CITY OF NORTH OAKS

PLANNING REPORT

RE: North Oaks - East Oaks Planned Unit Development
Anderson Woods Preliminary Plan (Subdivision)

FILE NO: 321.02 - 20.02

Exhibit F: Preliminary Plan (Subdivision)

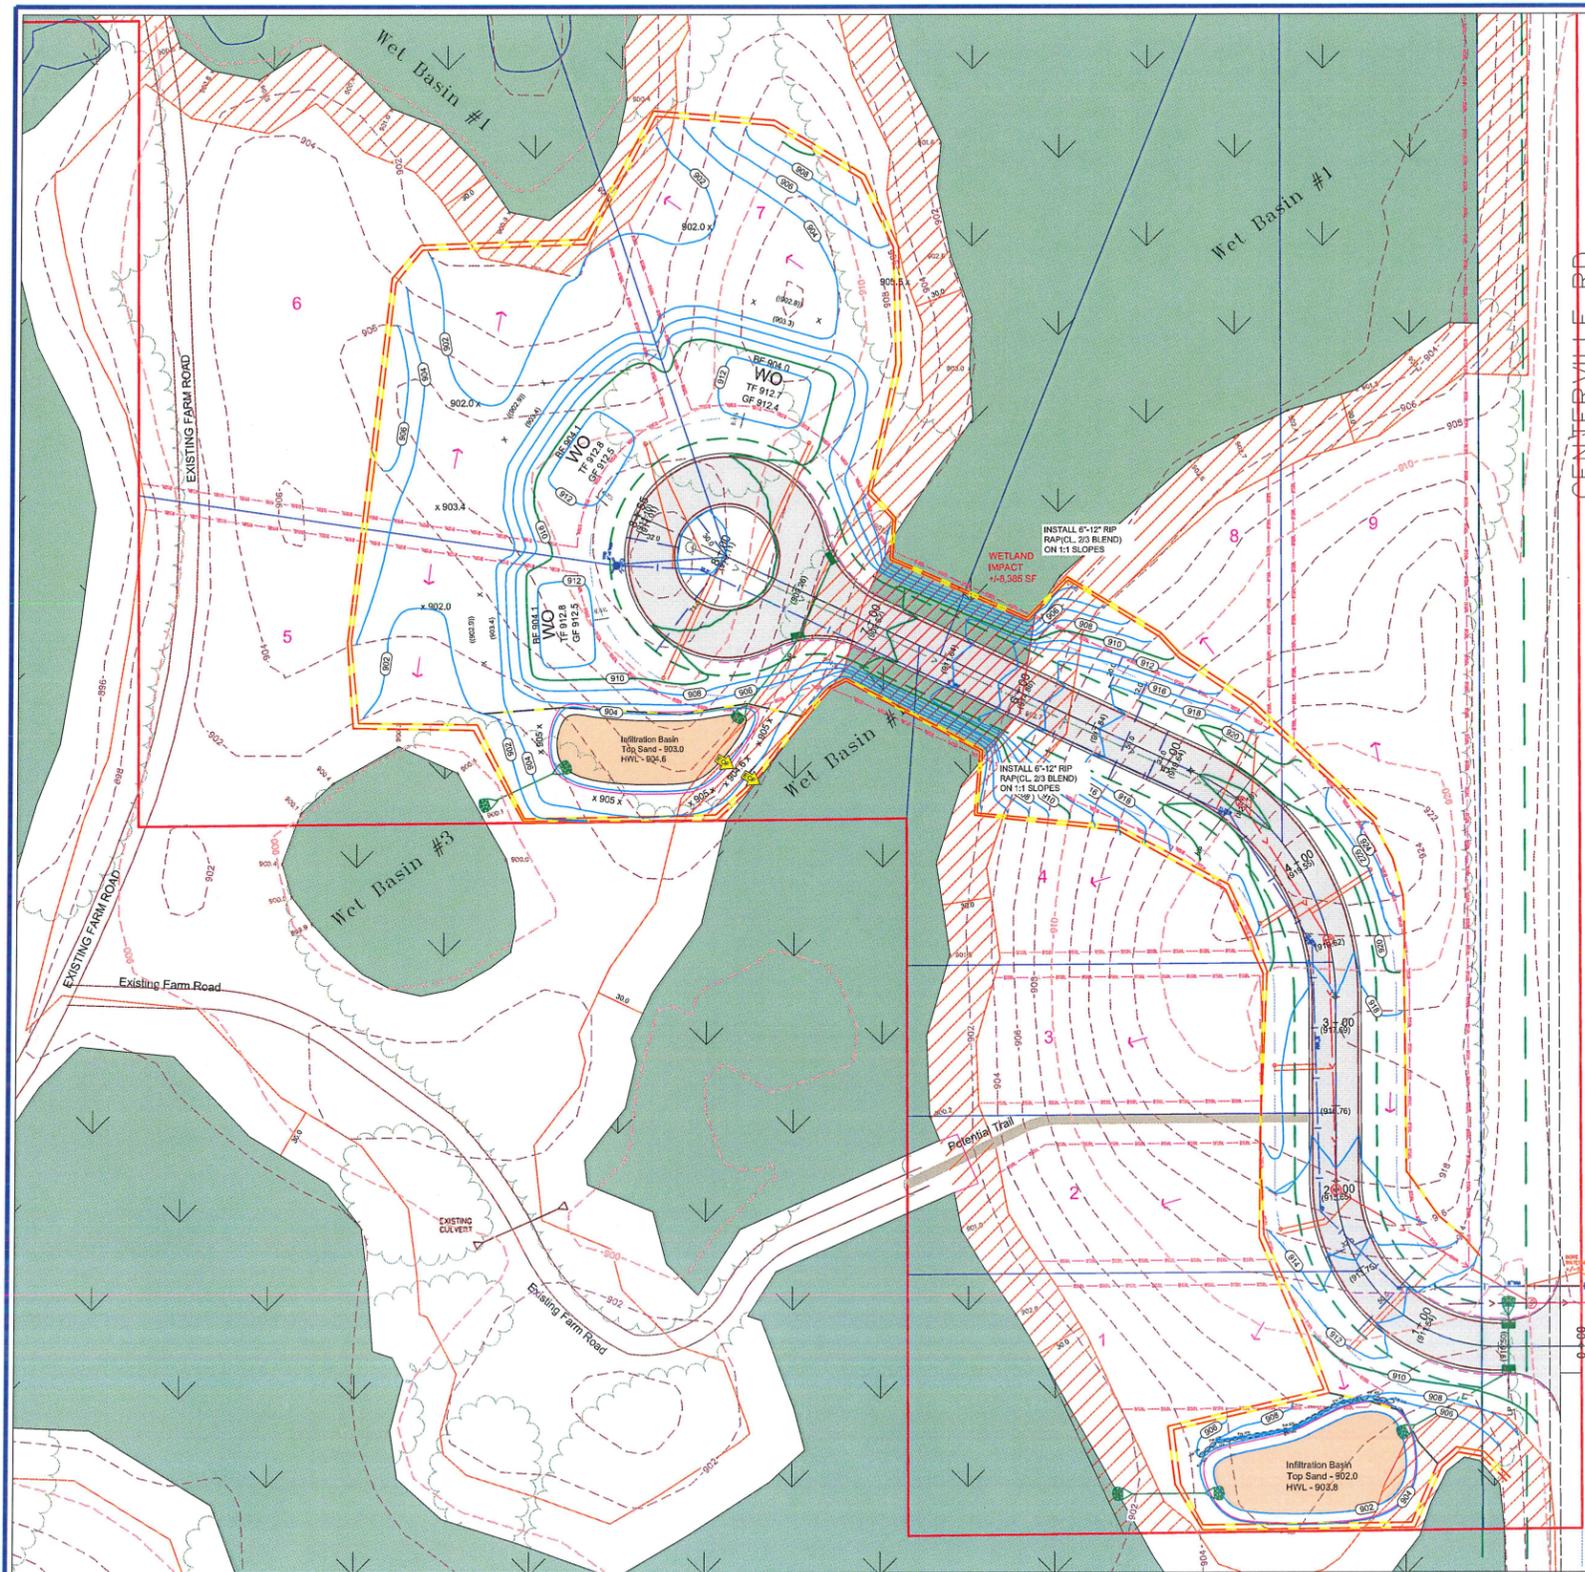
1. All final construction plans shall include applicable plan legends to facilitate comprehensive plan review.
2. Diligence in plan review prior to submittal of final construction plans to resolve Preliminary plan typos and inconsistencies.
3. Please remove all gender specific pronoun references on the preliminary engineering plans.
4. Ensure all primary plan features are adequately dimensioned and proposed dimensions are consistent with application narrative.
5. Existing conditions plan shall include field verification dates for topographic survey and wetland delineation.
6. Application narrative indicates proposed trail connection between Lots 5 & 6. Preliminary plans do not appear to illustrate this connection.

7. Application narrative indicates site plan shows boxes on each lot representing each proposed single-family home with approximate foundation size. Preliminary plans do not appear to illustrate approximate foundation sizes.
8. Lot sizes listed on FAR worksheet do not appear to match lot sizes indicated on Sheet 3, Preliminary Plat/Easement Plan.

Exhibit H: Preliminary Grading Plan

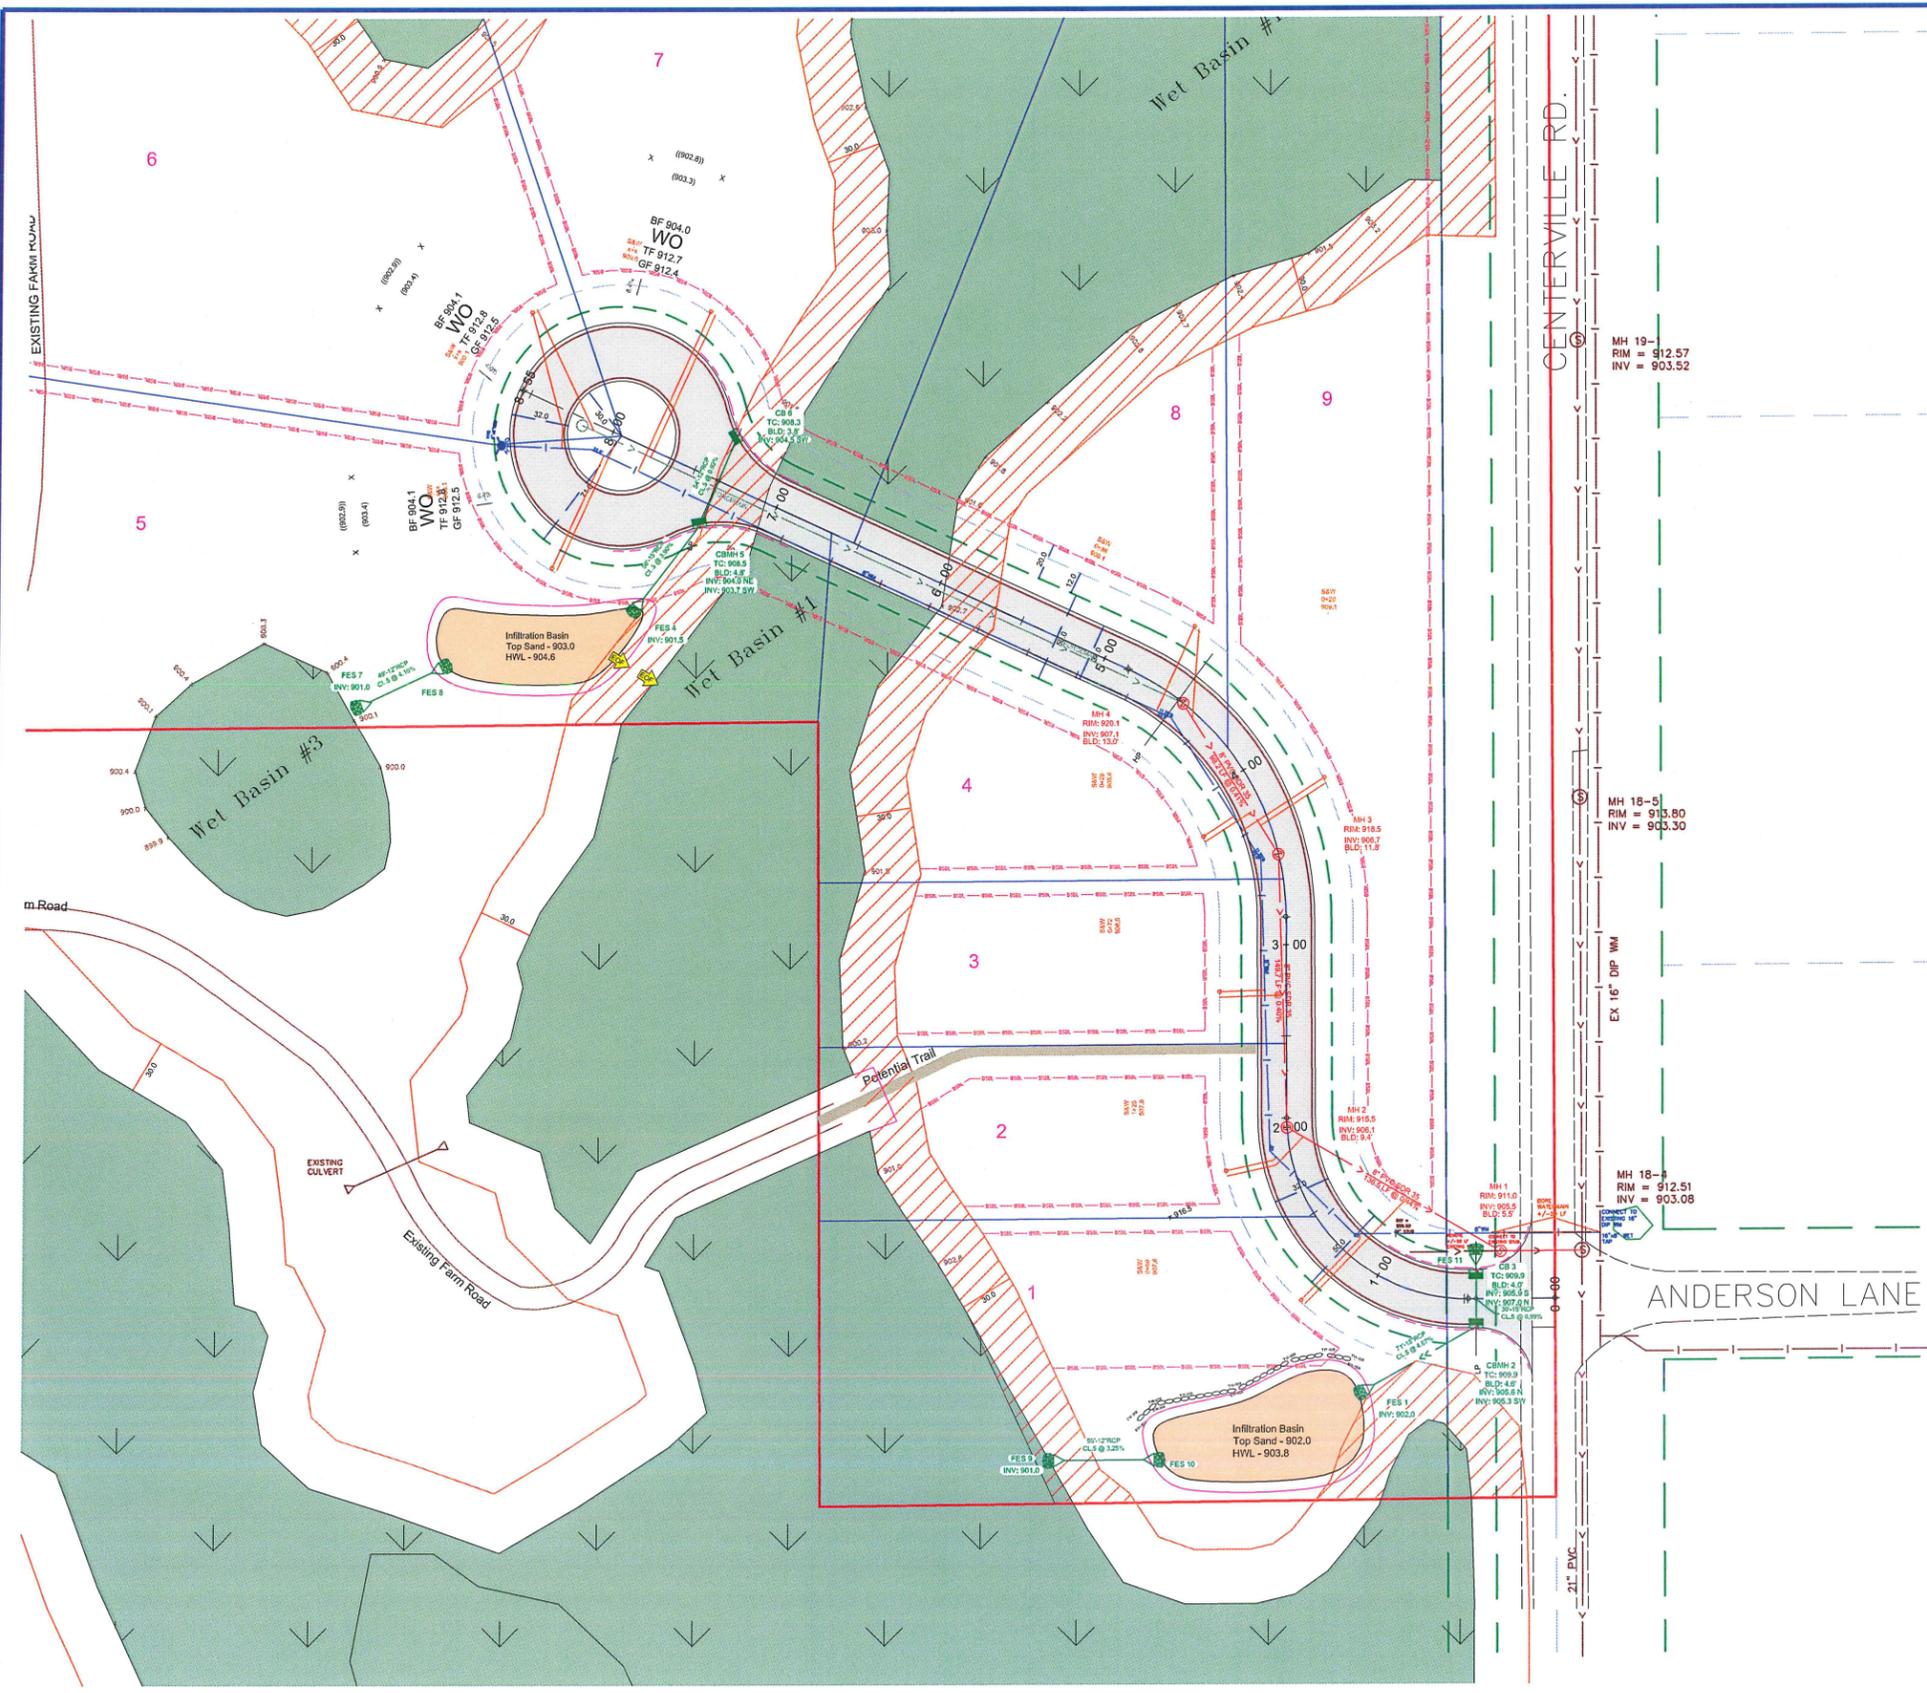
3. Staff recommends that the 100-year high water elevation for all site surface water features, including wetlands, be determined and shown on the final grading plan. These high-water elevations should be reviewed as a part of the building permit review process for the adjoining lots.

4. Identify the emergency overflow locations and elevations (EOF) on the final grading plan for wetlands, based on actual field topographic survey information.

12. A typical roadway cross section and cul-de-sac cross section shall be included as part of final construction plans.
13. Final grading plan should include high point elevations, grade breaks, typical slopes and drainage arrows.

15. North infiltration basin appears to be located within wetland buffer. Basin should be modified to comply with wetland buffer requirements per VLAWMO as LGU.
16. The proposed storm sewer and site grading final design and construction plans shall be reviewed and approved by the City Engineer, and VLAWMO.

Exhibit J: Preliminary Landscape / Sign Plan

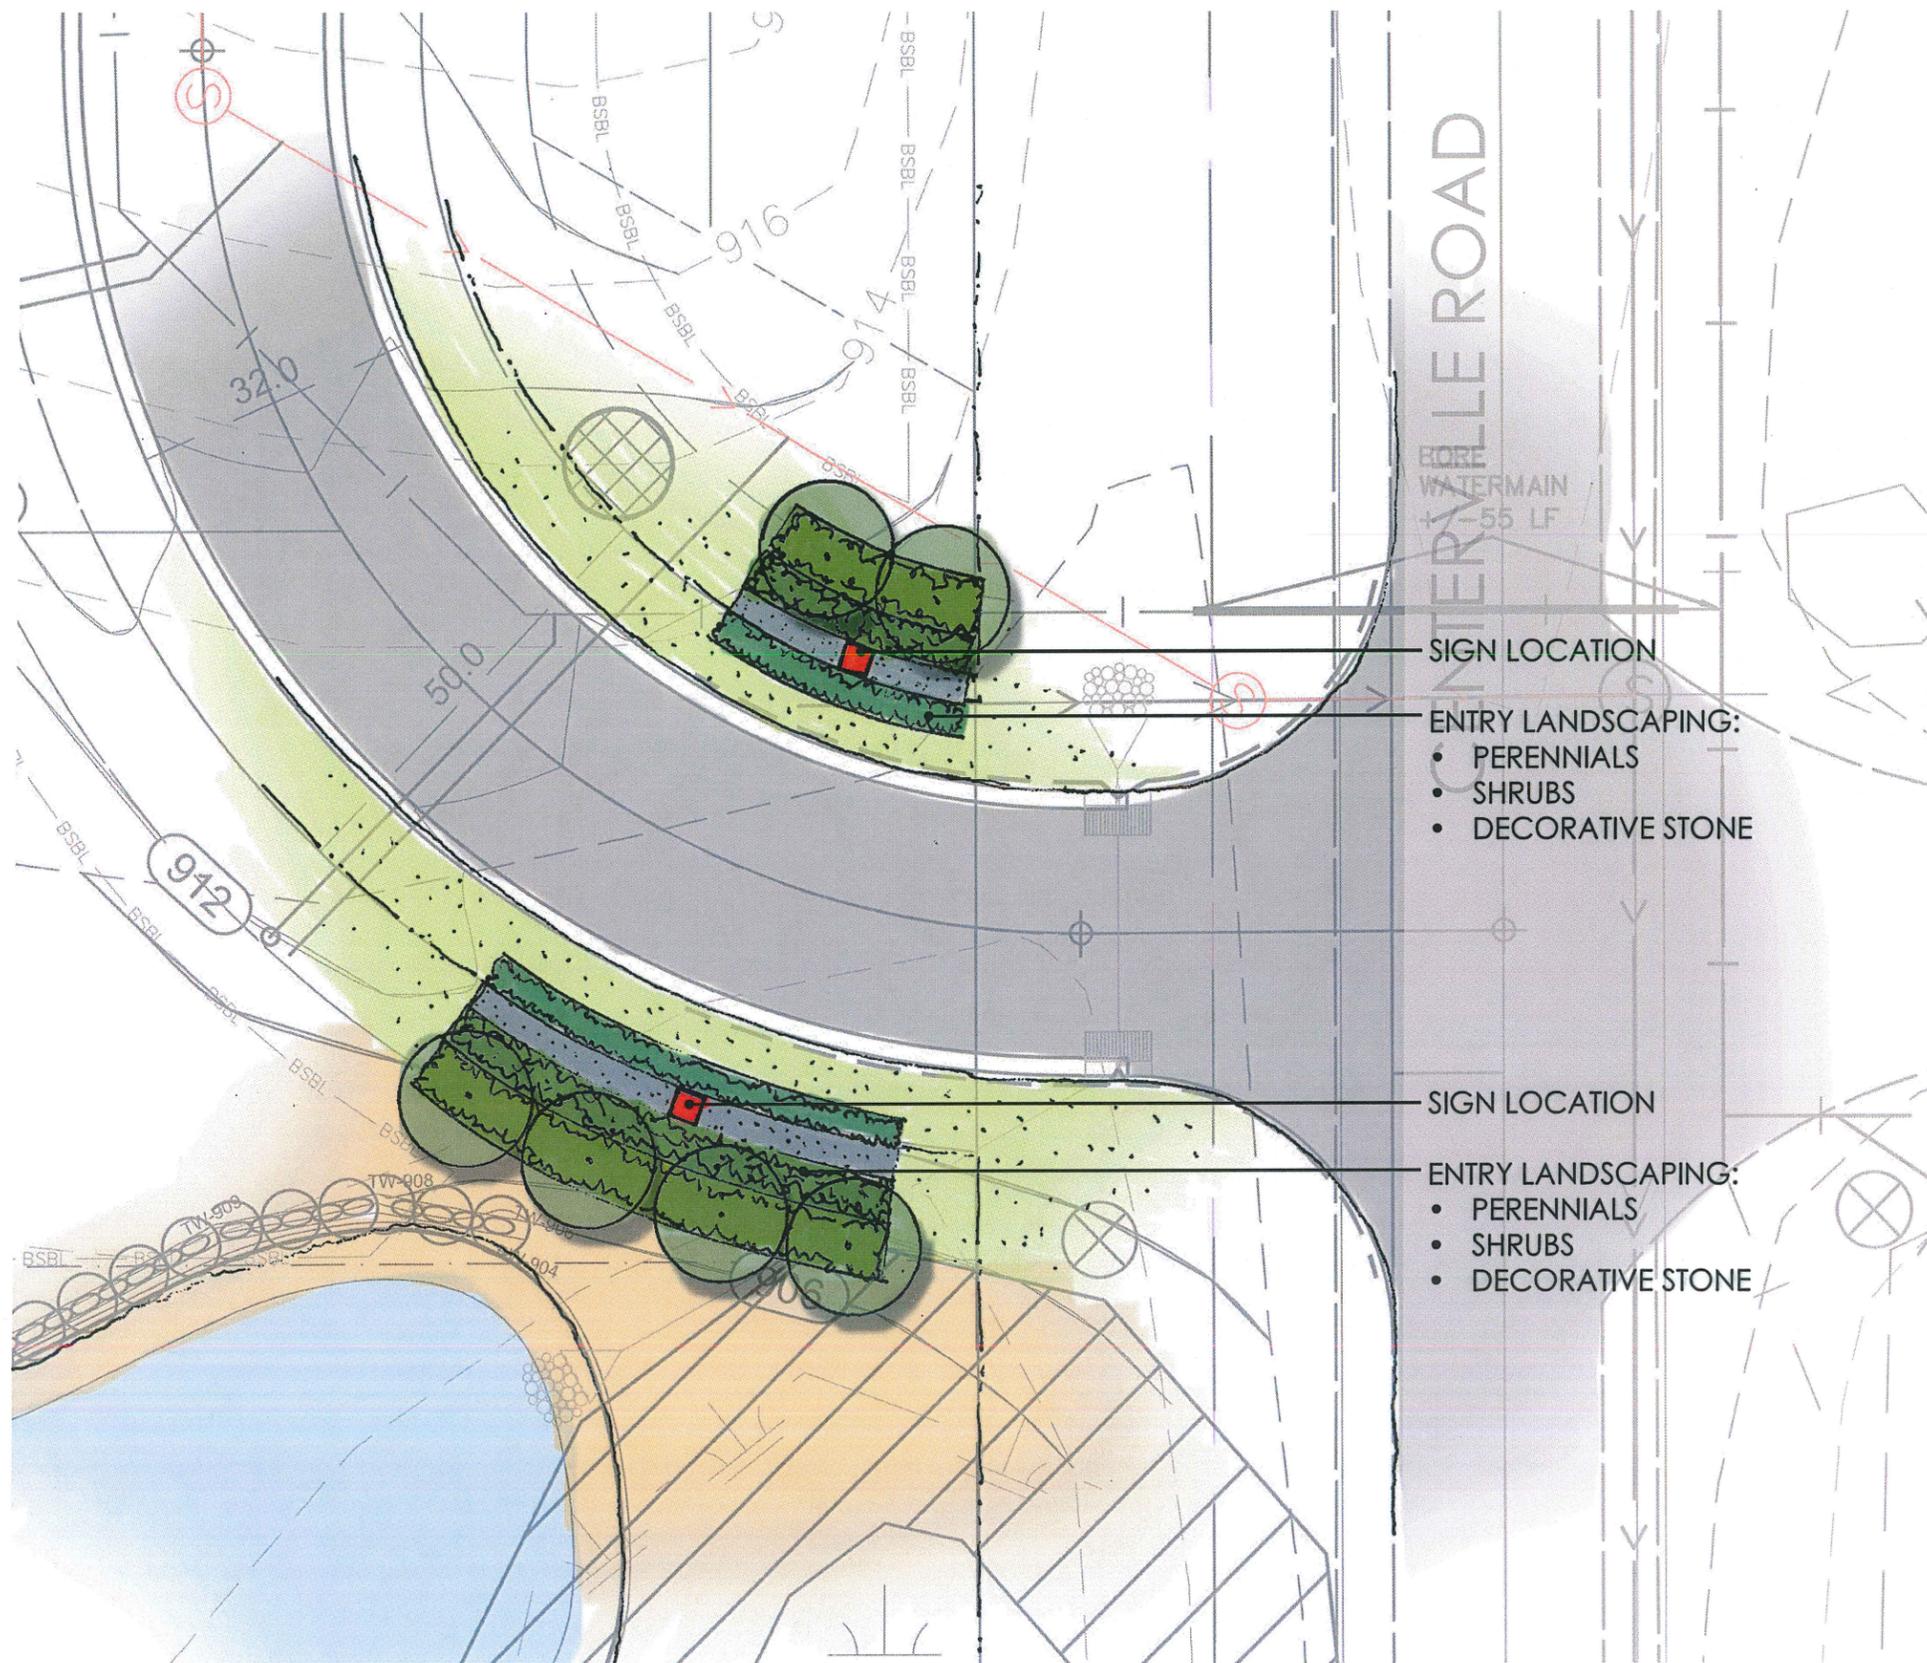
While the proposed monument sign appears to meet the preceding PDA requirements, additional detail (sign and setback dimensions) is necessary to make a final determination. As a condition of final subdivision approval, it is recommended that the proposed monument sign meet the preceding PDA requirements.
